Cambridge Waste Water Treatment Plant Relocation Project
Anglian Water Services Limited

Addendum to the Environmental Statement

Application Document Reference: 5.1.1
PINS Project Reference: WW010003
APFP Regulation No. 5(2)a

Revision No. 01
16 October 2023

Appendix A – Revised Order Limits

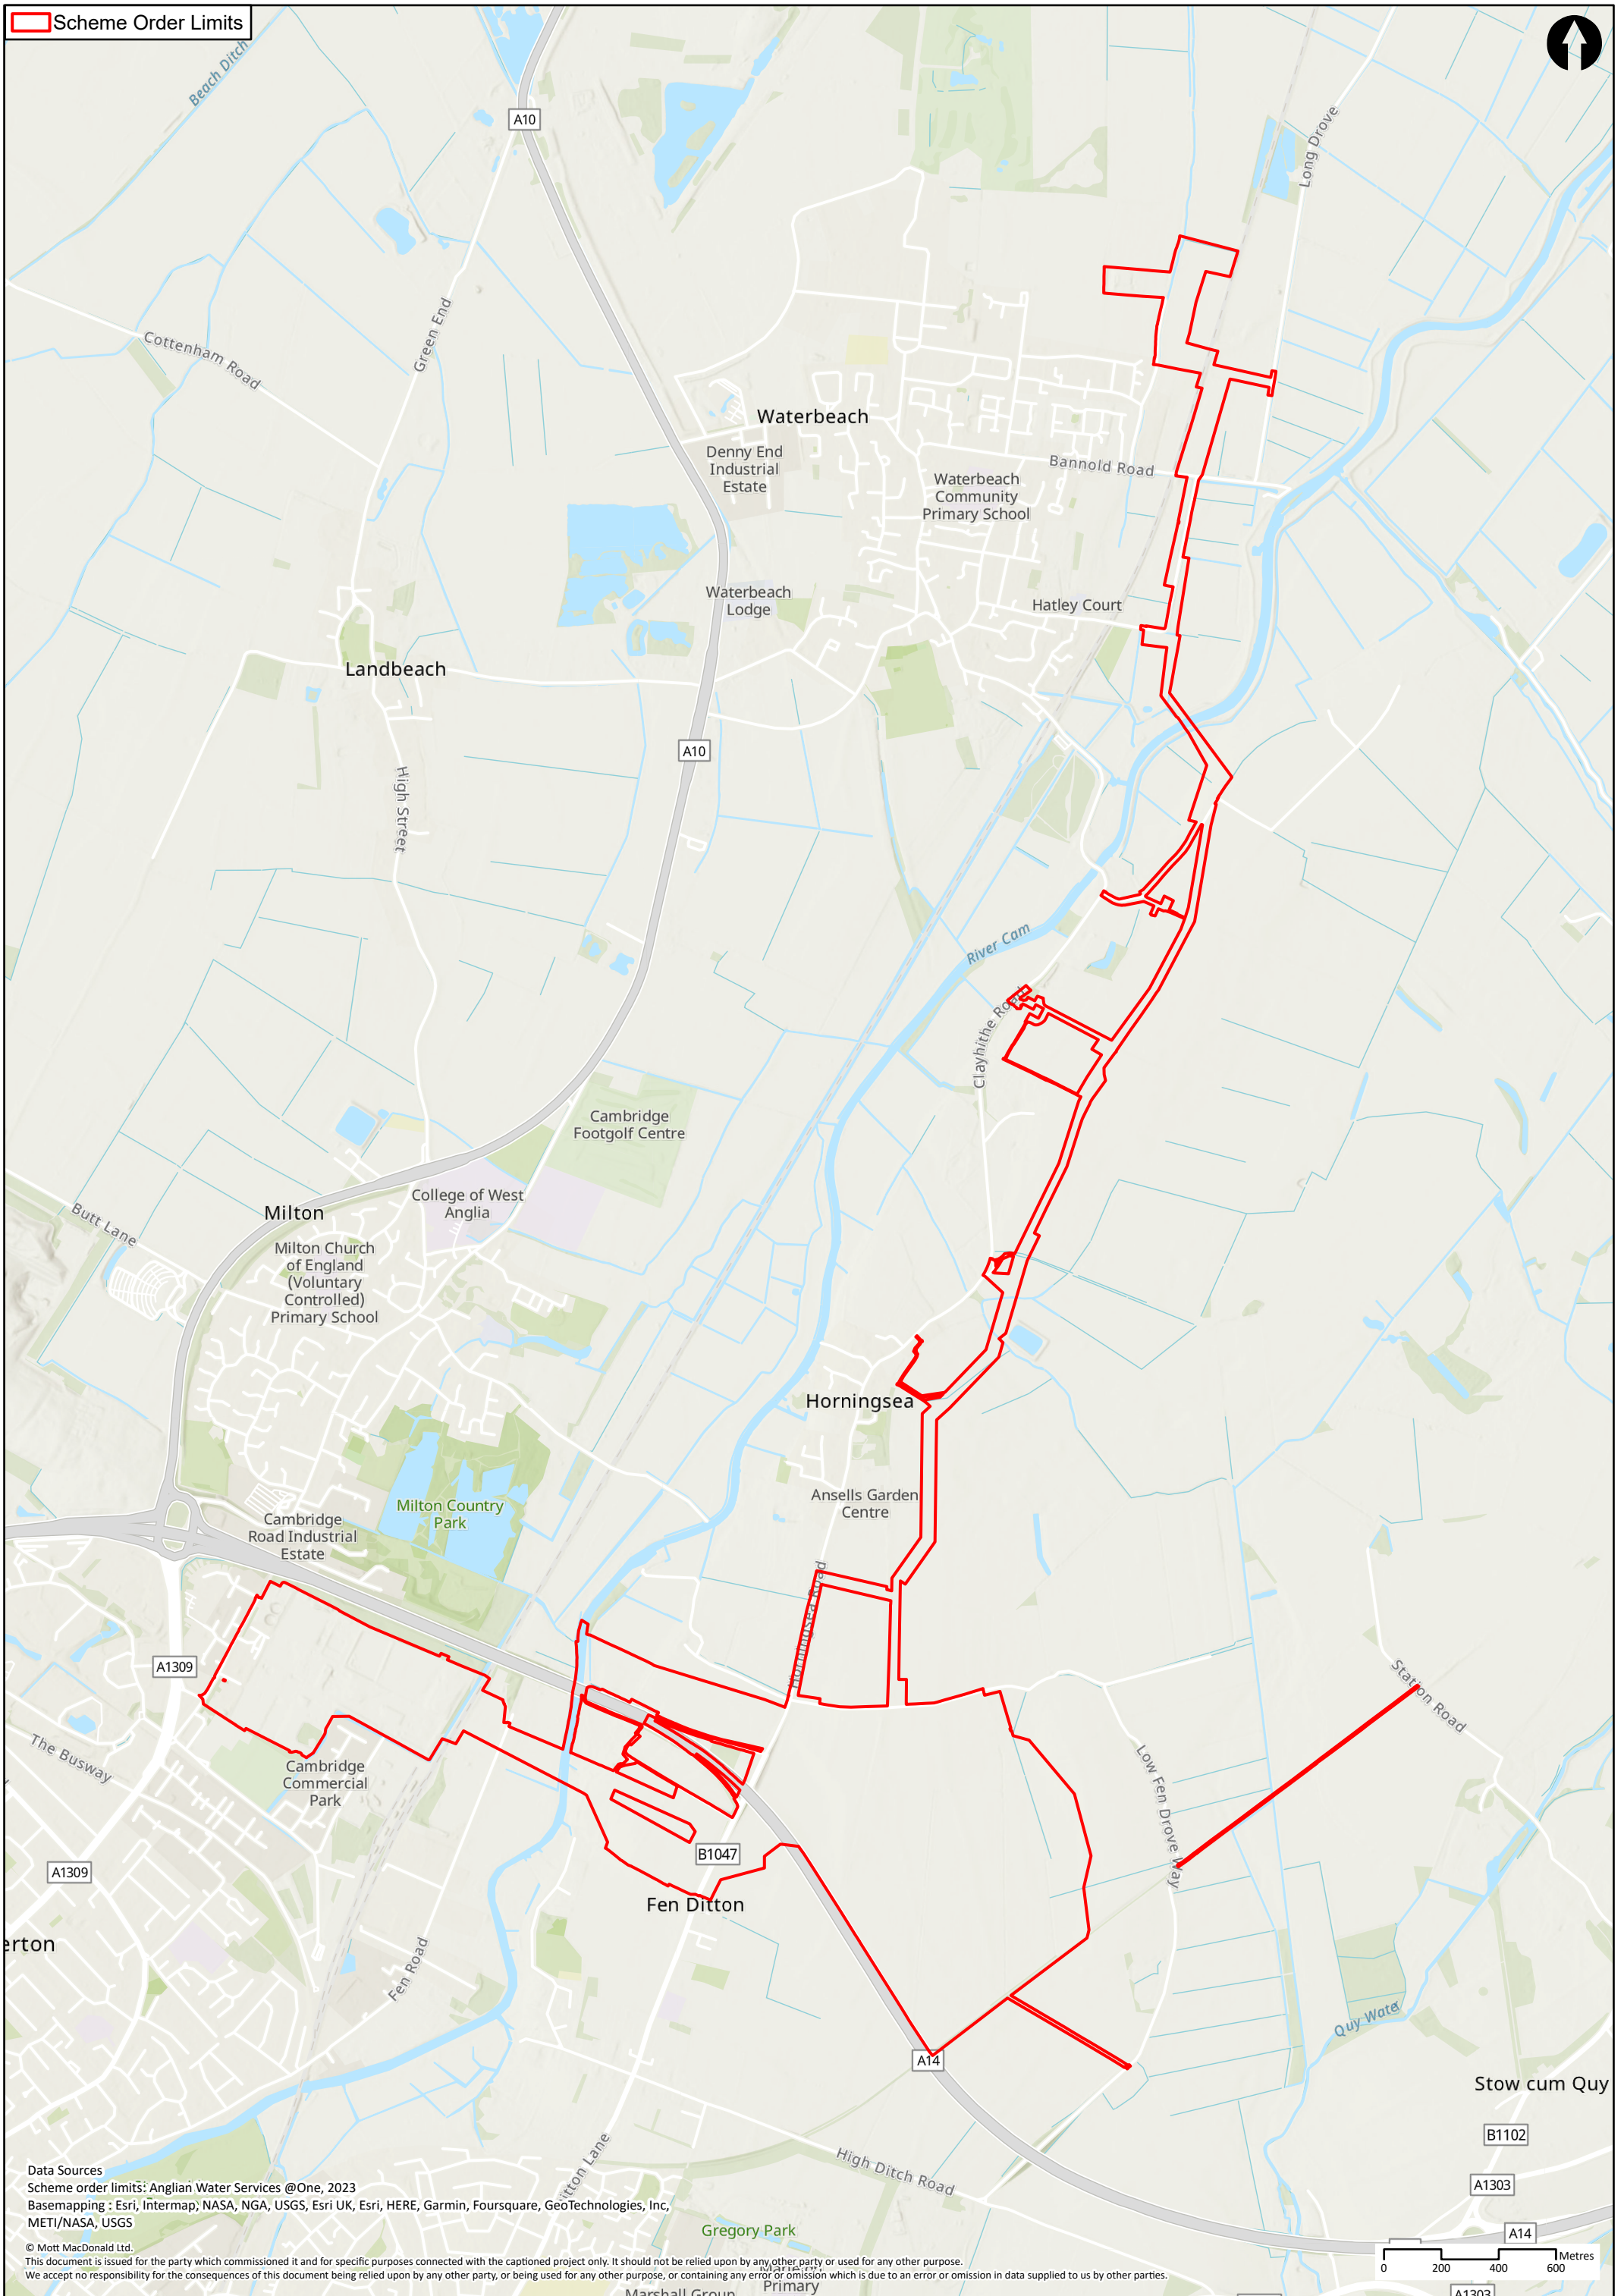
- 2.2.1 The Proposed Change results in the reduction in size of Works No. 33 (as shown on Works Plan Sheet 10 (Application Document Ref. 4.3.10)) to reduce the extent of the overlap with the proposed Waterbeach Railway Station.

- 2.2.2 The Order Limits have been reduced by 2.18ha. The Order Limits were previously 211.07ha, but as a result of the Proposed Change would reduce to 208.89ha. Updated Land Plans are provided with this change request (Application Document Ref. 4.4).

- 2.2.3 The revised Order Limits are shown in Appendix A. Any figures submitted previously within Books of Figures as part of the Original ES, should be reviewed with reference to the revised Order Limits in Appendix A.
